**ADDENDUM NUMBER 2:  
TOWN OF EXETER, NH  
COURT STREET over LITTLE RIVER  
BRIDGE REPLACEMENT  
CONTRACT DOCUMENTS AND TECHNICAL SPECIFICATIONS**

**Issued: May 15, 2017  
For Bids Due: May 22, 2017**

**PROJECT:** Court Street Little River Bridge Replacement  
Exeter, NH  
CMA Engineers Project No. 923

drawing no: R-3  
 sheet: 25 of 34

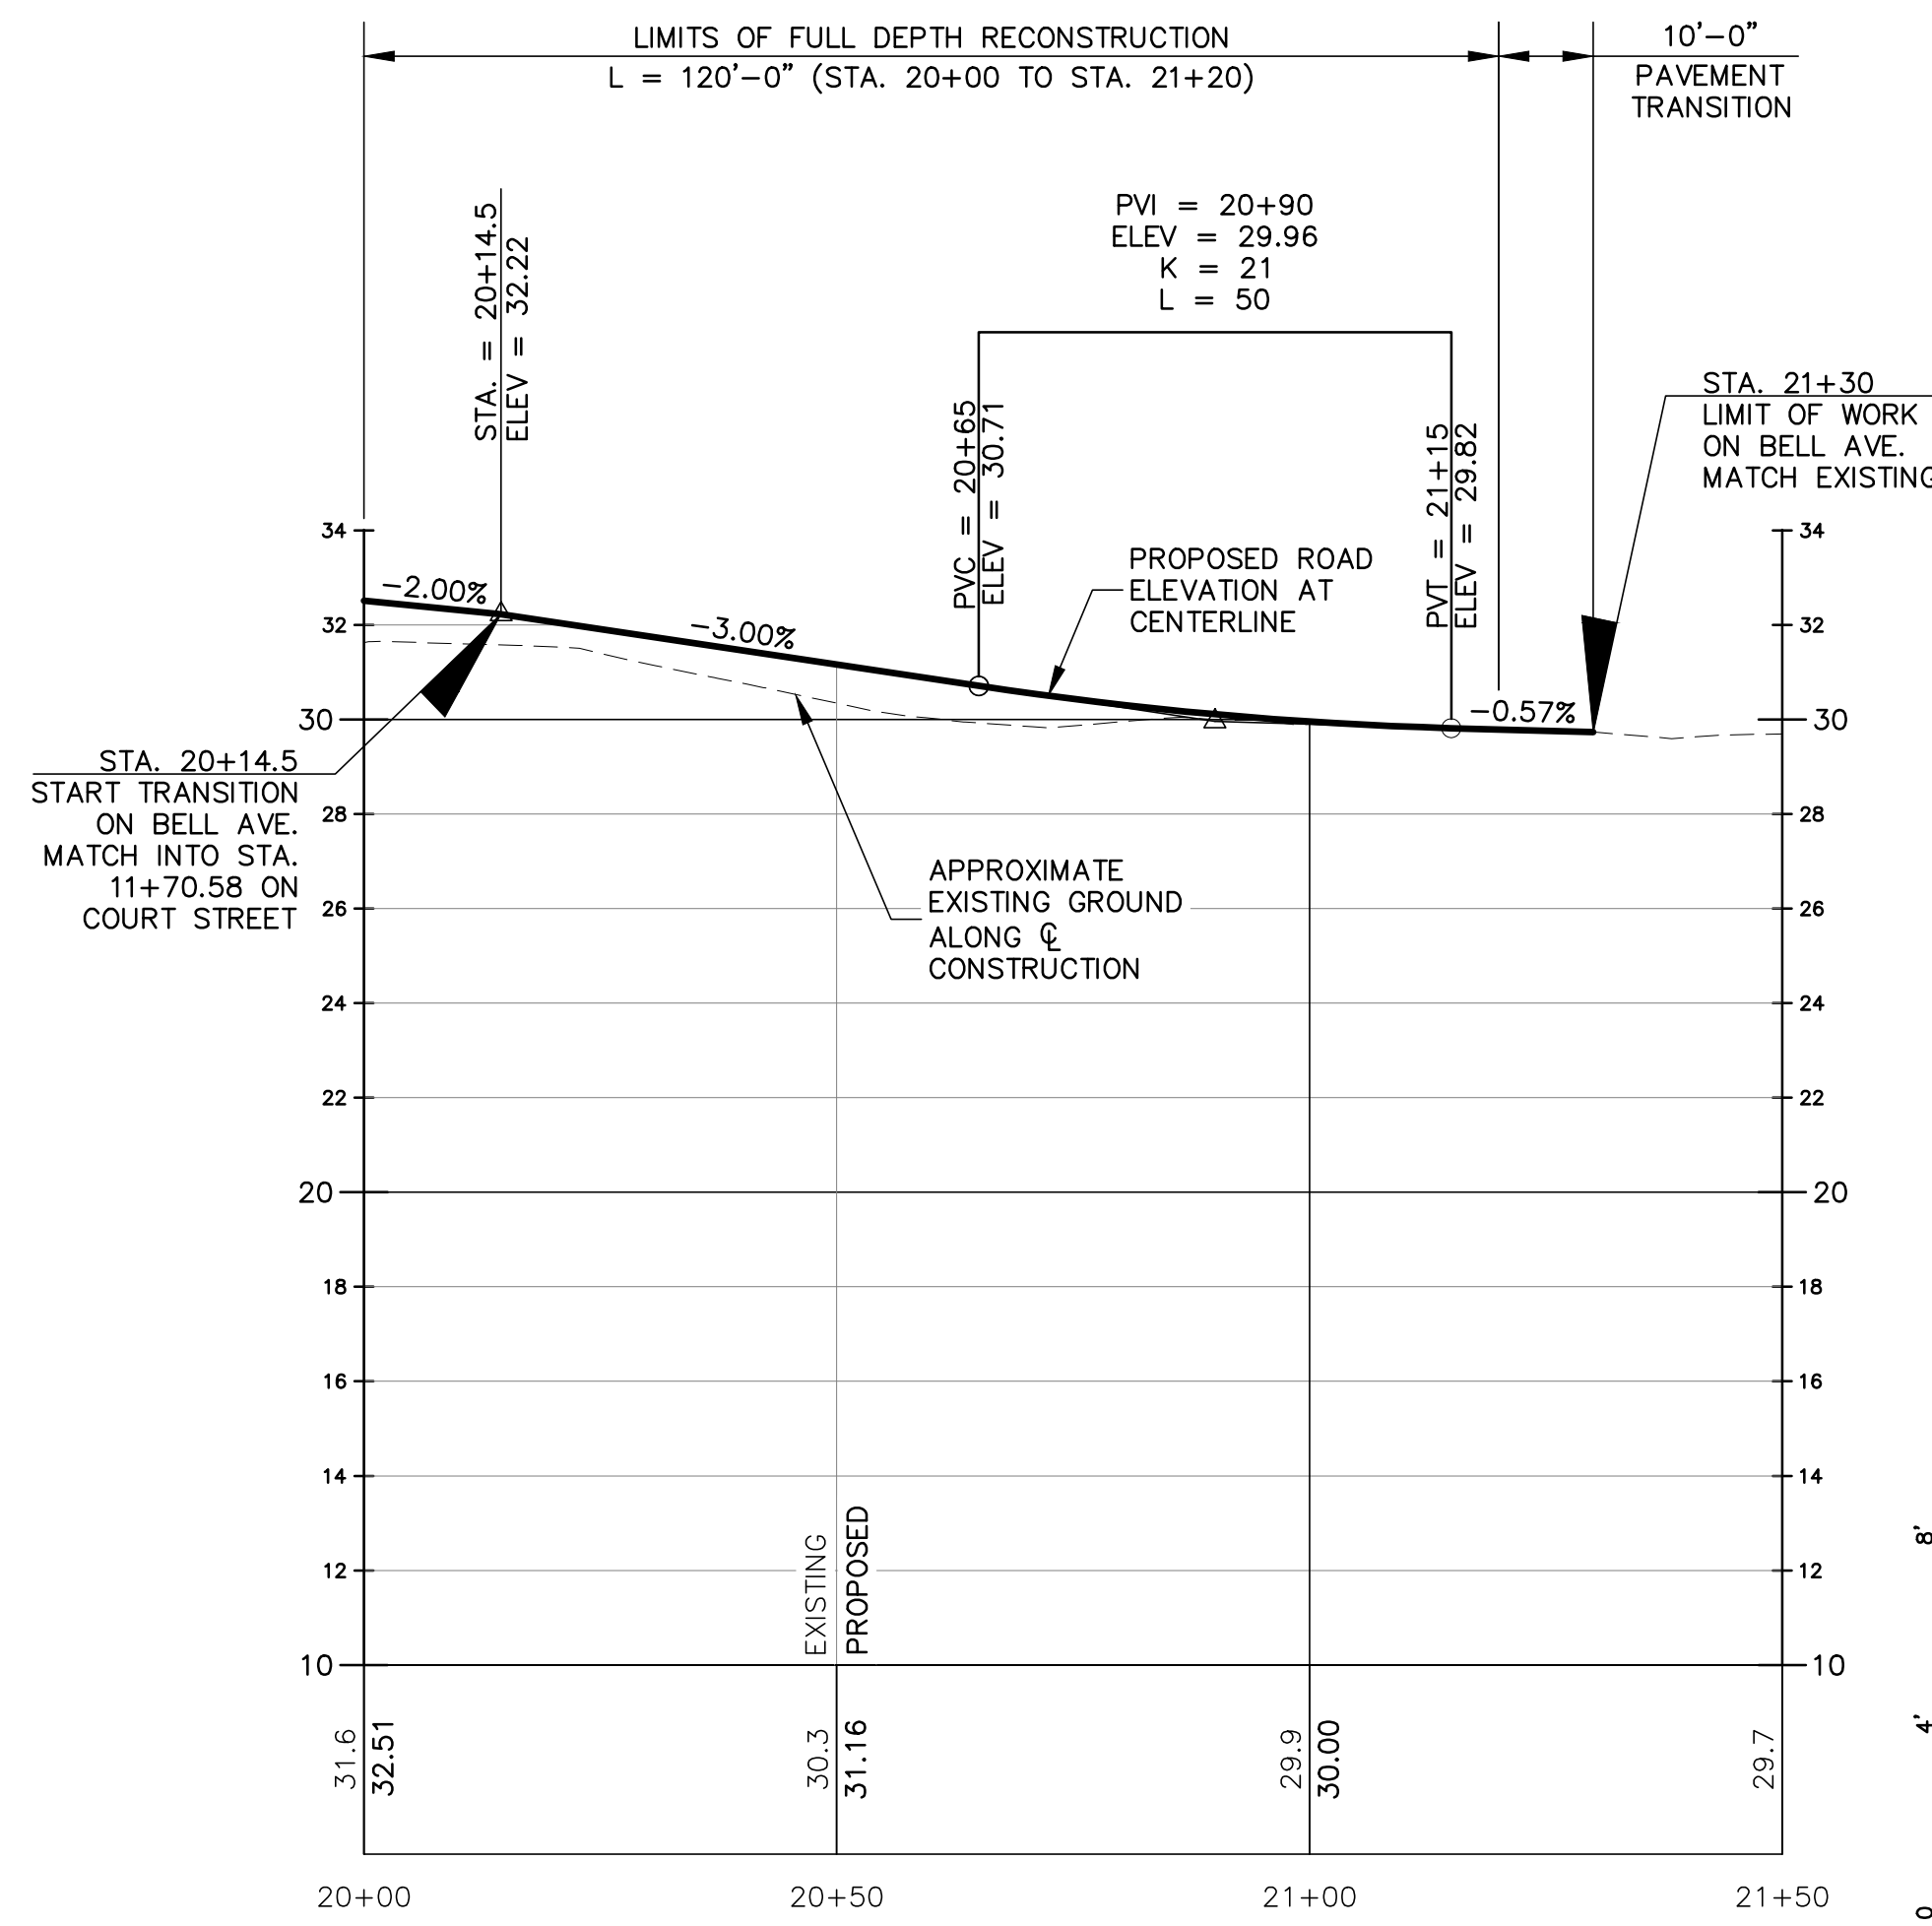
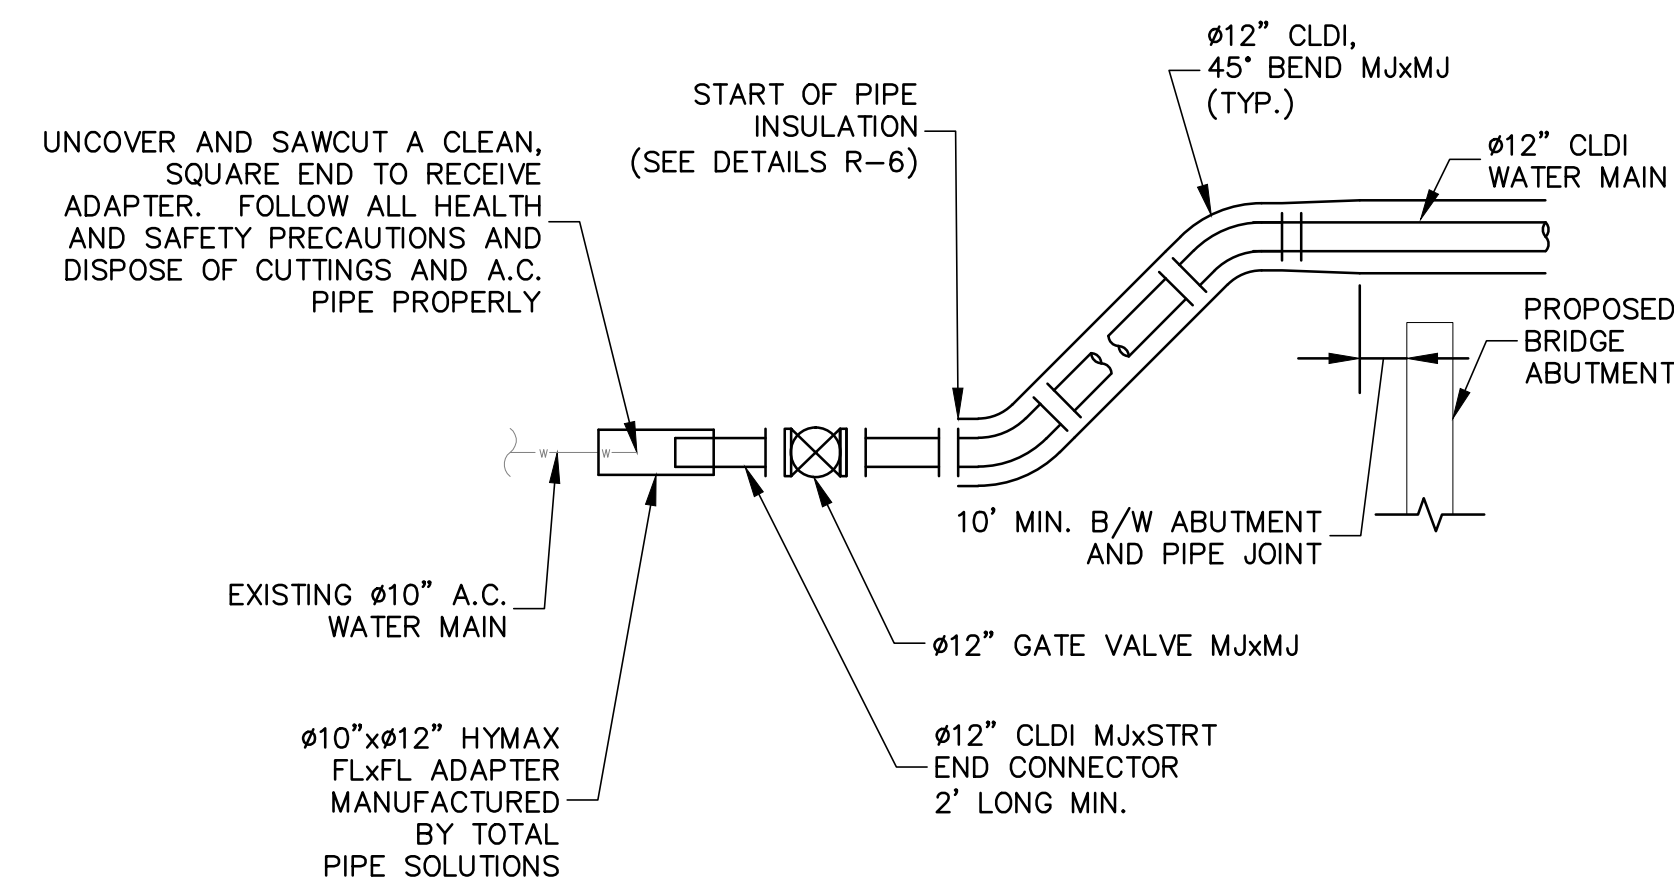
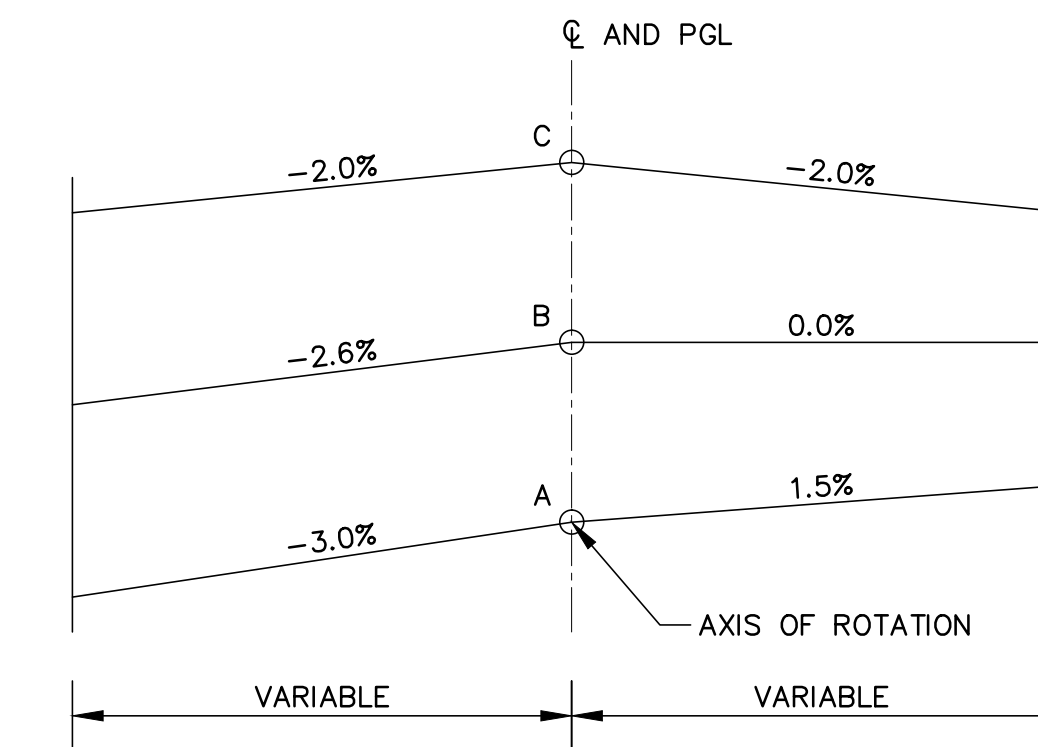
The sheets listed above have been modified to reflect changes to the drainage structures and drainage layout for the project. A note has been added to sheet R-1 to provide clarification regarding the removal of the dry hydrant near the northwest corner of the bridge.

ALTERATIONS TO DRAINAGE LAYOUT  
 ISSUED FOR BID  
 5/15/17  
 4/24/17  
 JLG  
 JLG  
 by: JLG  
 date:

- 1 STA 12+75, LT 35.8 FT TO STA 12+87, LT 27.0 FT  
 INSTALL 14 FT OF 12" RC PIPE  
 INSTALL 4" I.D. DMH, 12+87, RT 27.0 FT  
 12" INV. IN: 25.40'  
 12" INV. OUT: 25.15'  
 RIM: 31.00'

- 2 STA 12+87, LT 27.0 FT TO STA 13+76, LT 26.0 FT  
 INSTALL 86 FT OF 12" RC PIPE  
 INSTALL 4" I.D. CB-B, 13+76, LT 26.0 FT  
 12" INV. OUT: 26.25'  
 RIM: 30.25'

- 3 INSTALL 5' D.I. DMH, 14+08, LT 6.5 FT  
 12" INV. IN: 26.25' (SEE DRAINAGE NOTE 3)  
 30" INV. IN: 23.65' ± (EX.) (SEE DRAINAGE NOTE 2)  
 30" INV. OUT: 23.65' ± (EX.) (SEE DRAINAGE NOTE 2)  
 RIM: 31.85'

- 4 STA 14+08, LT 6.5 FT TO STA 14+08, RT 16.9 FT  
 INSTALL 20 FT OF 12" RC PIPE  
 INSTALL 4" I.D. CB-B, 14+08, RT 16.9 FT  
 (WITH ECCENTRIC TOP, ROTATE PER PLANS)  
 12" INV. IN: 26.80' (SOUTH)  
 12" INV. IN: 26.80' (NORTH)  
 12" INV. OUT: 26.80'  
 RIM: 31.40'

- 5 STA 13+64, RT 13.0 FT TO STA 14+08, RT 16.9 FT  
 INSTALL 41 FT OF 12" RC PIPE  
 INSTALL DROP INLET TYPE D-B, 13+64, RT 13.0 FT  
 12" INV. OUT: 27.65'  
 RIM: 31.50'

- 6 STA 14+08, RT 16.9 FT TO STA 14+71, RT 17.8 FT  
 INSTALL 60 FT OF 12" RC PIPE  
 INSTALL 4" I.D. CB-B, 14+71, RT 17.8 FT  
 12" INV. OUT: 27.10'  
 RIM: 30.80'

- 7 STA 15+35, LT 7.0 FT TO STA 15+36, LT 30.8 FT  
 INSTALL 21 FT OF 12" RC PIPE  
 (CONNECT TO EX. DMH (SUBSIDIARY))  
 12" INV. = 25.45' (SEE DRAINAGE NOTE 3)  
 INSTALL 4" I.D. CB-B, 15+36, LT 30.8 FT  
 12" INV. IN: 25.95' ± (EX.) (SEE DRAINAGE NOTE 2)  
 12" INV. OUT: 25.70' (SEE DRAINAGE NOTE 2)  
 RIM: 31.45'

- 1) CONTRACTOR TO HAVE ENGINEER VERIFY ALL DRAINAGE STRUCTURES AND PIPING LISTED BELOW, PRIOR TO REMOVAL.
- 2) DRAINAGE STRUCTURES TO BE REMOVED:  
 STA. 13+06 LT 22.4'  
 STA. 13+51 RT 11.0'  
 STA. 14+59 RT 19.2'  
 STA. 15+35 LT 21.8'
- 3) ALL PIPING CONNECTED TO STRUCTURES BEING REMOVED SHALL ALSO BE REMOVED UNLESS PIPING WILL BE RECONNECTED TO A NEW STRUCTURE.
